UNITED STATES PATENT AND TRADEMARK OFFICE

10/618,095

Office Action Summary

DETAILED ACTION

**FIG. 2**

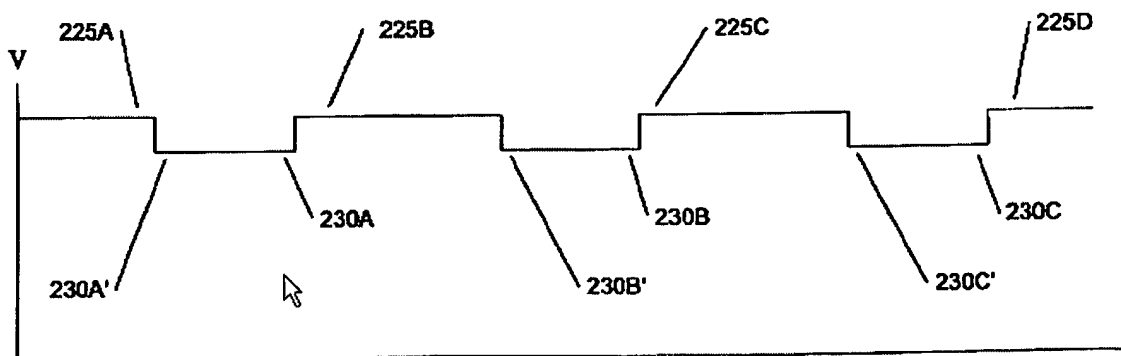
As to claim 1, Podrazhansky discloses in figures 1-4 a method comprising:

drawing a substantially constant first current pulse 210 [see fig.2; column 3, line 35] from an energy storage cell 11 during a first time period 210A between a starting time 220A and an ending time 220B [see fig.2];

the battery voltage is measured to provide voltages during the discharge pulses, and the voltage differences among two or more of these measured voltages are used [see fig.2]

means 16 for drawing a substantially constant first current pulse 210 [see fig.2; column 3, line 35] from an energy storage cell 11 during a first time period 210A between a starting time 220A and an ending time 220B [see fig.2];

means for measuring the battery voltage during the discharge pulses, and the voltage differences among two or more of these measured voltages are used [see fig.2]; and

Fig - 1

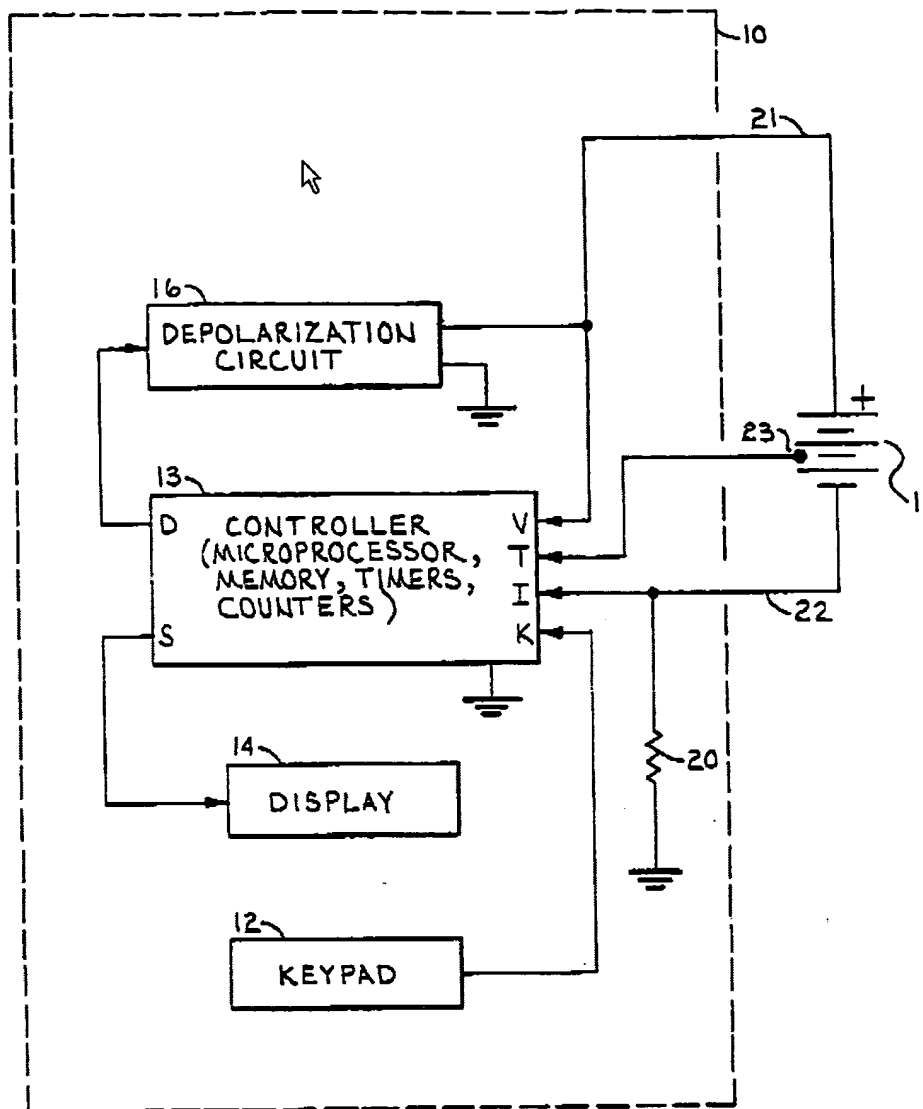
Claim 20: "a processor circuit, **coupled to or including** the difference circuit" is not clear as a) fig.1 shows the difference circuit as part of the processor, and b) the use of "or" makes the claim language confusing because it is not clear what applicant is actually claiming. Furthermore, applicant is reminded that "or" should only be used with alternate terms, e.g., rod or bars, etc. To continue prosecution it was assumed the processor circuit **includes** the difference circuit.

As to claim 20, Podrazhansky discloses a system comprising:

an energy storage cell 11;

a current source/sink circuit 16, coupled to the cell, to draw a substantially constant first current pulse;

a difference circuit 13, coupled to the voltage measurement circuit, to compute a difference between the first and second voltages;

and a processor circuit 13, including the difference circuit, the processor circuit including a memory circuit [see fig.1] to store first data/curve or LUT [see column 1, lines 44-51] relating cell
